Entegra EX5000

Multi-Function Display Pilot's Guide Addendum

Software Release 8.1

600-00248-000 Rev: 01

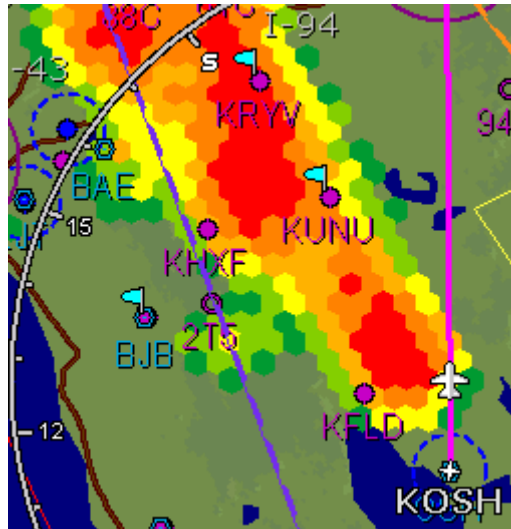
There is an additional choice to the Wx Ovly button on the Map page.

- **SatIR** - If installed and available, displays 2-Way Datalink Infrared Satellite cloud information on the map, using shades of gray. Lighter shades of gray indicate colder, generally higher clouds, while darker shades of gray indicate warmer, generally lower clouds. Like DL RDR, the 2-way Datalink uses two-way messaging to send your present position and flight plan to the Avidyne Network Operations Center (NOC), which then sends you only the data for your position or flight plan, depending on your Datalink Setup preferences.

Note: Diagonal stripes indicate the boundary of available Datalink radar or SatIR data. If Datalink radar or SatIR is unavailable in a particular area, hatched lines appear in that area.

Not for Navigation Watermark on Chart display

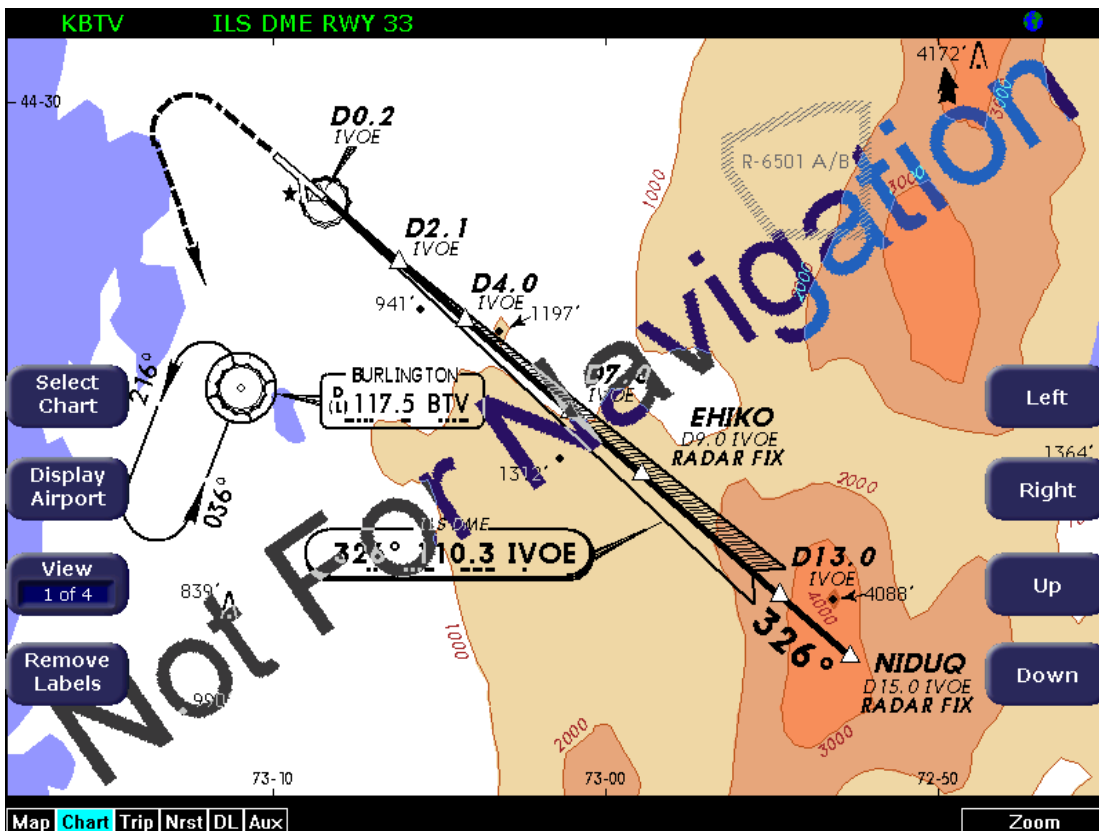
CMax™ charts are valid for a period of 56 days. Charts will be displayed normally for 10 weeks after the chart expiration date.

After 10 weeks from the chart expiration date, charts will display a "NOT FOR NAVIGATION" watermark. The Ownership symbol and flight plan legs are removed from charts that cannot be used for navigation.

Chart Selection Page with VFR and IFR charts listed

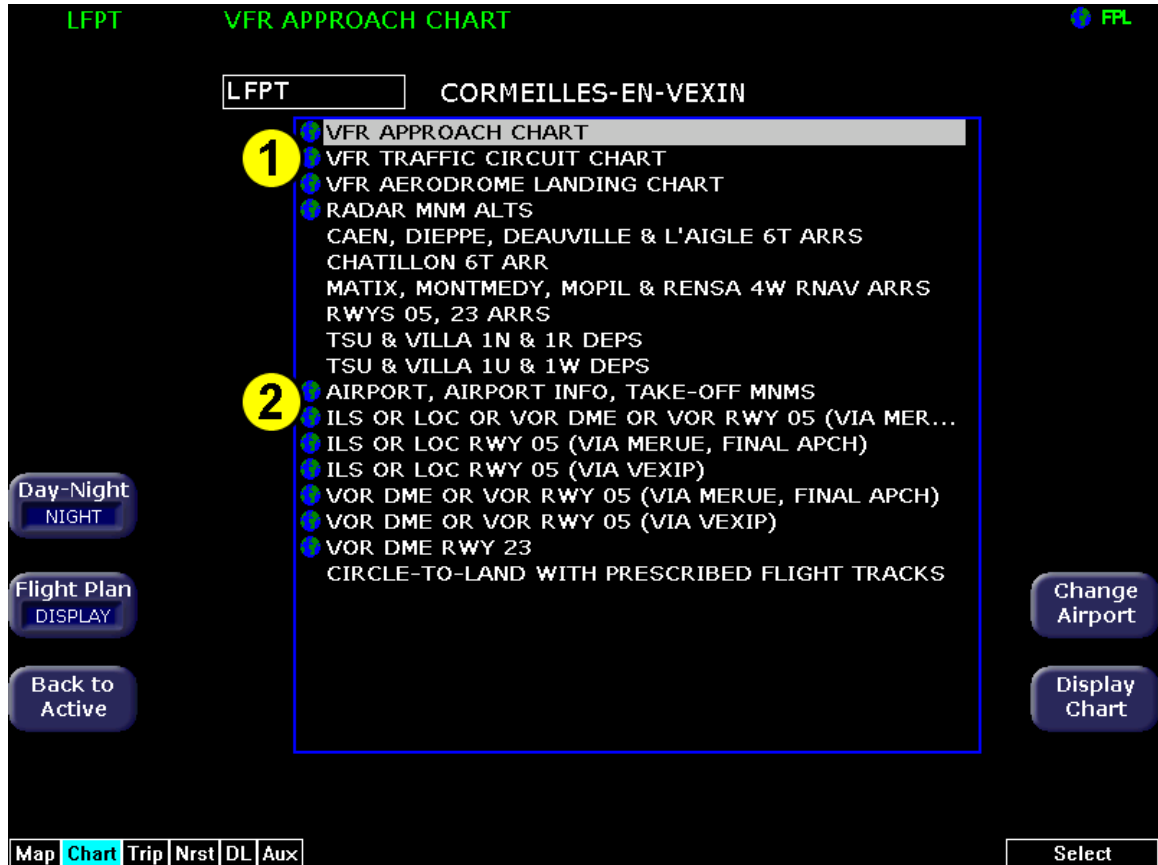
European VFR Charts can be included in the CMax subscription from Jeppesen. If loaded, these European VFR Charts can be accessed like standard CMax charts. JSUM version 2.1.5 or later must be used to download European VFR Charts.

- 1) **VFR Charts**—If loaded, VFR charts will be listed first in the list of CMax charts for a given airport.
- 2) **IFR Charts**—If loaded, standard CMax IFR charts will appear second on the CMax Selection Page below European VFR charts.

If a VFR chart is selected pressing “Display Airport” will display the VFR airport diagram. Likewise, if an IFR chart is selected, pressing “Display Airport” will display the standard Jeppesen airport diagram.
